October 2017 Update

ESL5

— Electronic Safe Lock —

IMPORTANT NOTE

NEW 3.3-VOLT ESL5

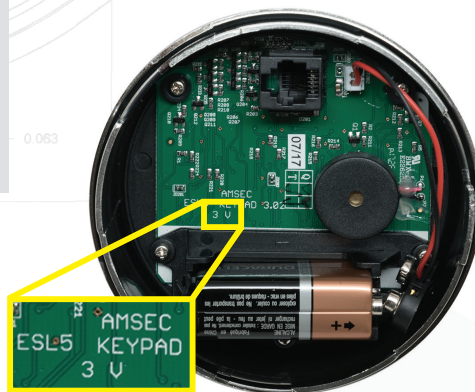
The microprocessor previously used in Amsec's ESL5 lock is no longer available. The circuitry has been redesigned with a new lower-voltage microprocessor. This change will lower the lock's current draw and improve battery life. It is important to note that the new 3.3-volt locks and keypads are not interchangeable with the old 5.0-volt parts. Caution must be exercised when ordering replacement keypads. The notes below outline how to tell the difference between the old 5.0-volt components and the new 3.3-volt parts.

KEYPAD - "3 V" is visible on the circuit board (see photo above)

LOCK - Serial number has 8 digits and begins with EL. Example: EL20000001

BASE - EL serial number listed along with replacement keypad part number label

OLD 5.0-VOLT ESL5

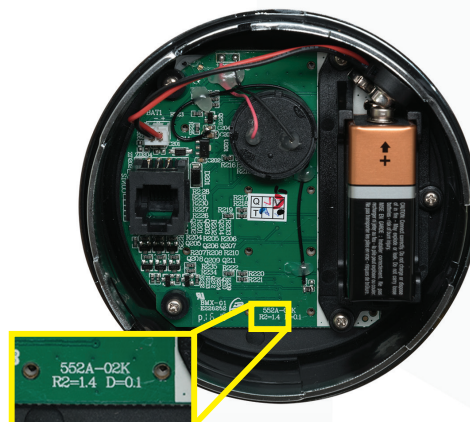
KEYPAD - "R2=1.4" is visible on the circuit board (see photo above)

LOCK - Serial number has 6 digits and begins with either EL5 or EL7. Example: EL500001 or EL700001

BASE - EL5 or EL7 serial number listed. May or may not have replacement keypad part number label
